Post-Accident pH of the Perry Containment Water Pool

**E. C. Beahm and T. A. Dillow
Chemical Technology Division**

Date Published — March 1999

**Prepared for the
U.S. Nuclear Regulatory Commission
Office of Nuclear Reactor Regulation
Under Interagency Agreement DOE 1886-N260-4J**

Fig. 1. Results obtained by titration with 0.1 M HNO₃.

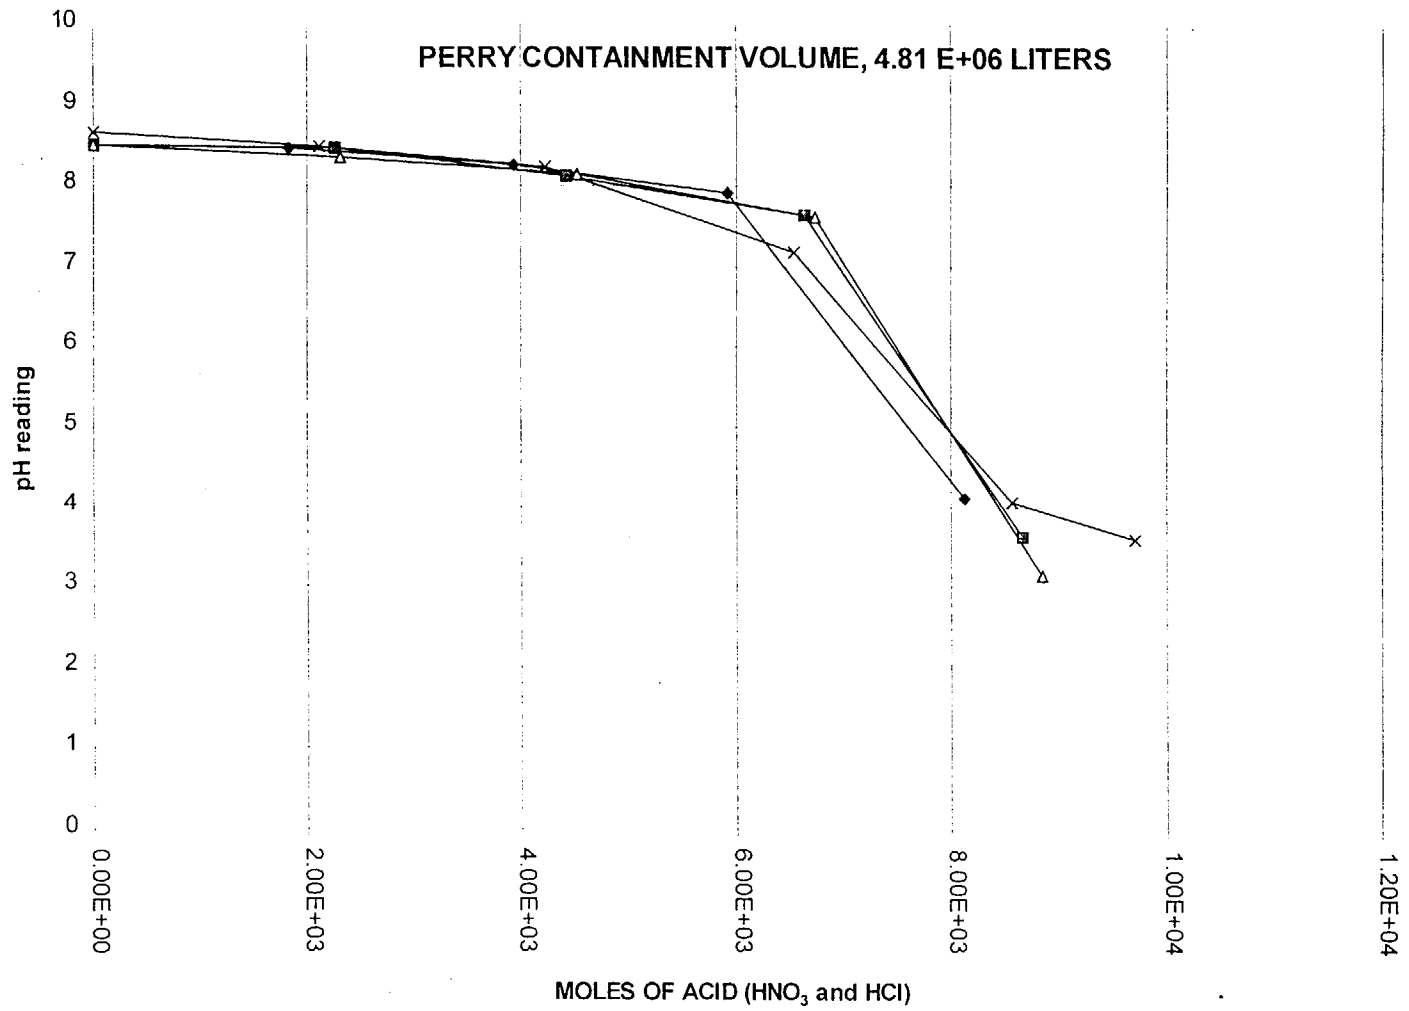
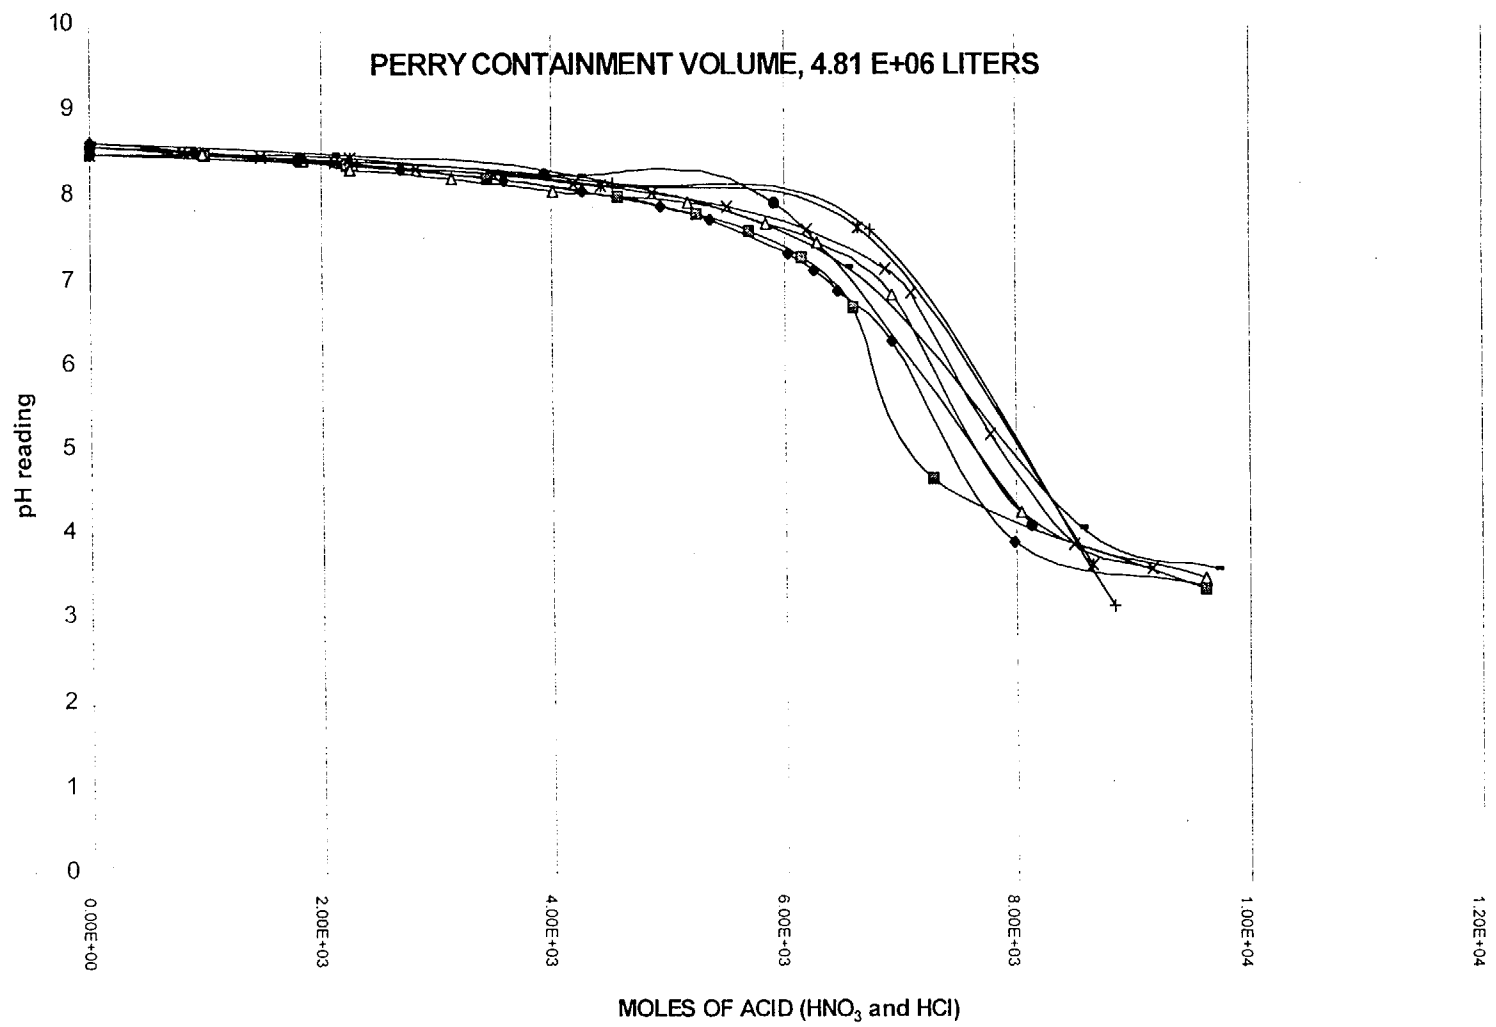
Figures 1 and 2 show pH readings as a function of acid addition. These plots were scaled to 4.81×10^6 L to correspond to the Perry containment. Eight samples, four of which were titrated with 0.1 M HNO_3 and four of which were titrated with 0.01 M HNO_3 , were tested. The initial pH measured was 8.5 to 8.6. This is consistent with the Polestar calculation. The Polestar calculation also gave a pH of 8.0 at 30 days. The acid addition, by Polestar calculation, was $\sim 4 \times 10^3$ mol. The measured values confirm the pH at this acid addition. The plots in Figs. 1 and 2 show that the buffer capacity would be exceeded with the addition of $\sim 7 \times 10^3$ mol of acid. The data used to prepare Figs. 1 and 2 are listed in Table 1.

Fig. 3. Energy deposition rates due to fission product decay.

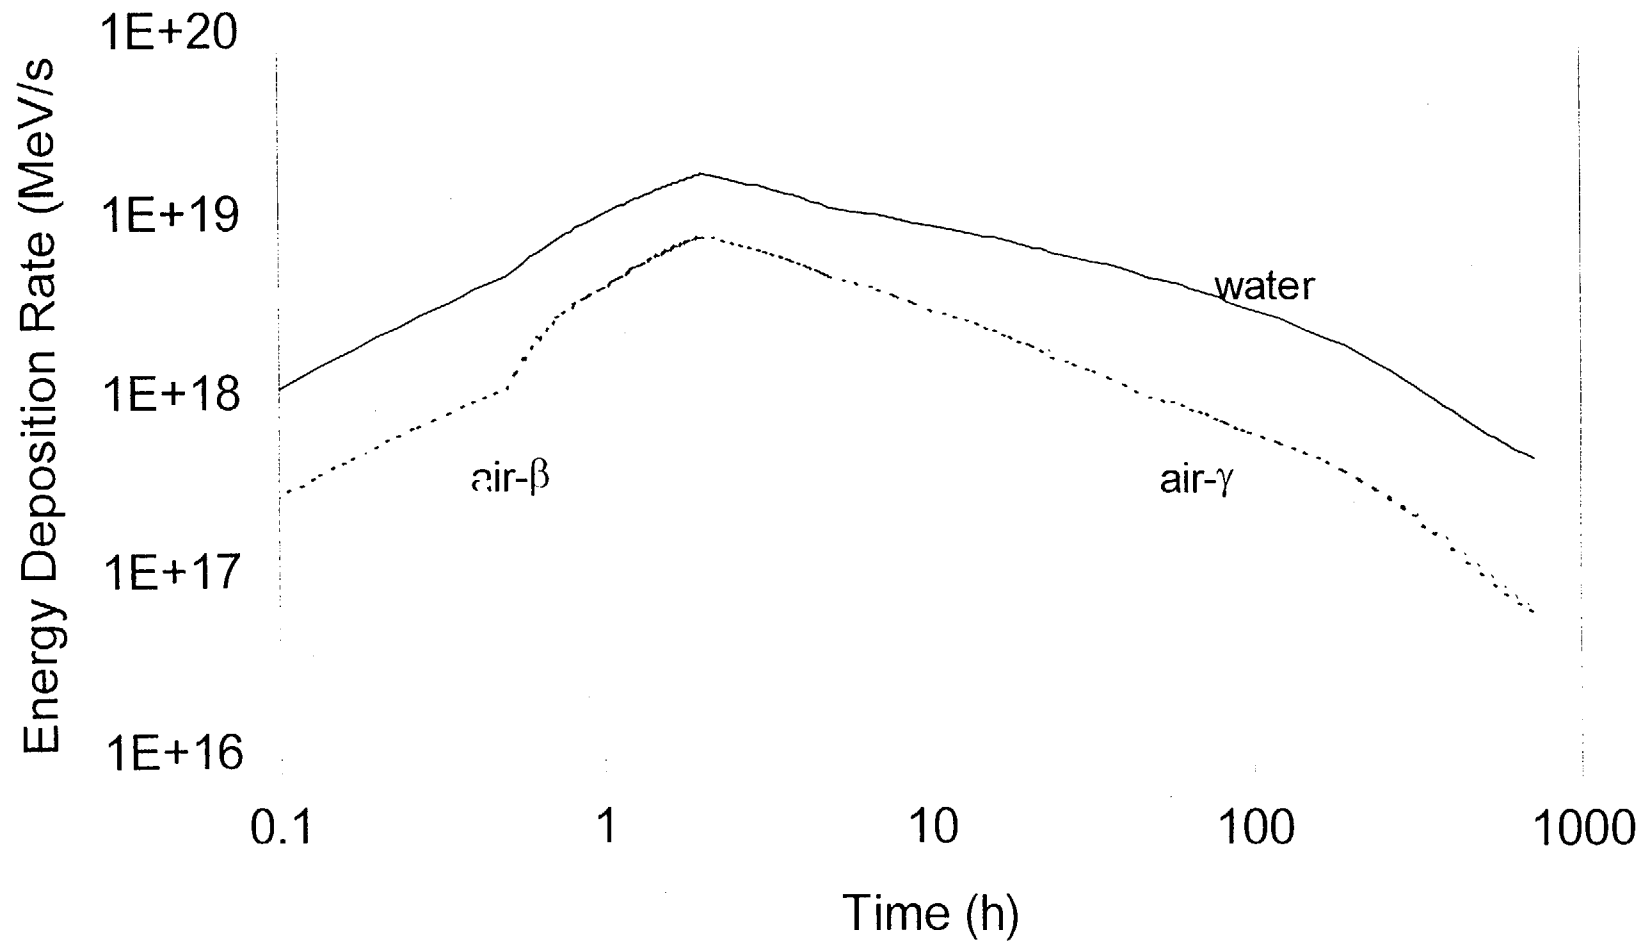
Using assumptions 1–4, energy deposition rates to both air and water can be calculated. These are shown in Fig. 3. Note the rate of increase at 0.5 h — due to the increase in fission product source rates — and the peak at 2 h — the end of fission product releases. The gradual decline after 2 h is due to the reduction of fission product inventory as the result of radioactive decay.

Fig. 4. Radiolytically generated acids in containment.

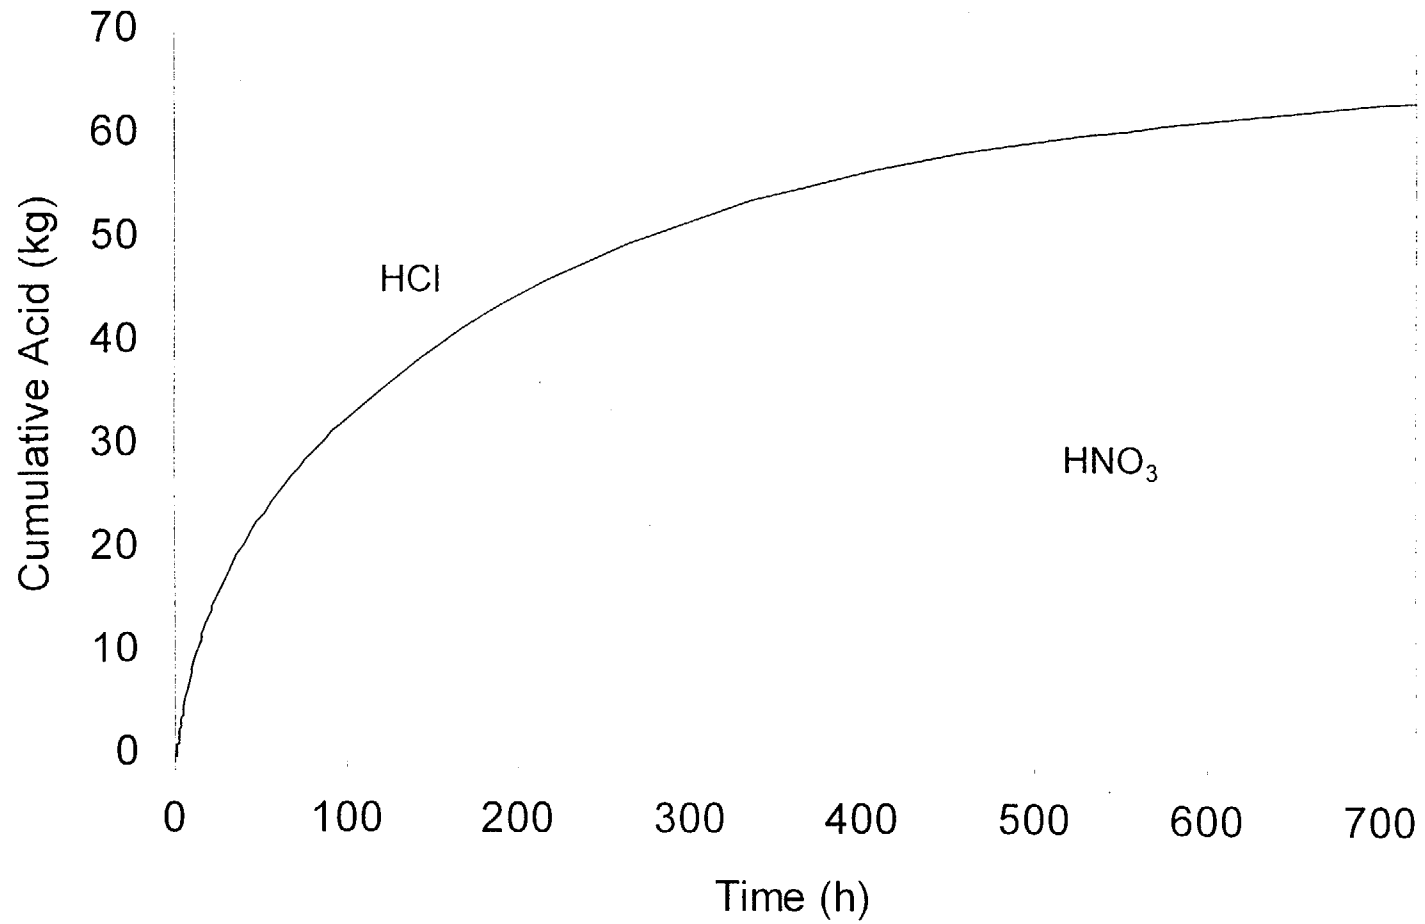
Following assumptions 8 and 9 and using the energy deposition rates in Fig. 3, the generation of containment acids can then be computed (see Fig. 4 and Table 2). The total acid generated at 30 days is about 2250 mol, roughly half that of the Polestar calculation. The discrepancy is likely because Polestar tailored the HCl generation from Hypalon specifically to the Perry Plant, resulting in about twice the generation rates for HCl. The current analysis assumes the generic model of Ref. 4. In addition, the current analysis considers the reduction in energy deposition rate over time for a given mass of each fission product group. If such an effect was also considered by Polestar, it has not been described.
